## PIC18F45J10 Family Data Sheet Errata

In the PIC18F45J10 Family Device Data Sheet (DS39682A), the following clarifications and corrections should be noted. Any silicon issues related to this device will be reported in a separate silicon errata. Please check the Microchip web site for any existing issues.

### 1. Module: Electrical Specifications (V/F Performance)

**FIGURE 23-1: PIC18F45J10 FAMILY VOLTAGE-FREQUENCY GRAPH (INDUSTRIAL)<sup>(1)</sup>**

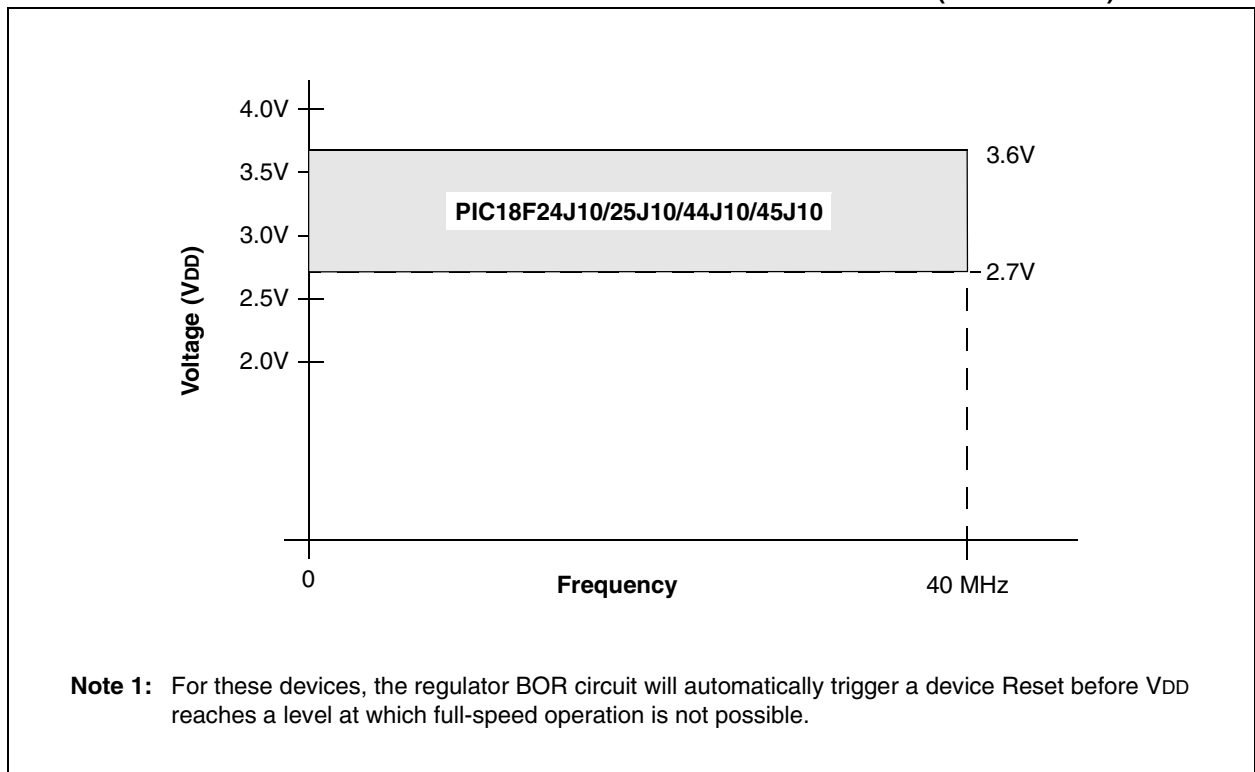
Figures 23-1 and 23-2 of the device data sheet, documenting frequency performance of the devices across the VDD range, have been updated. The new versions of the graphs are presented below.
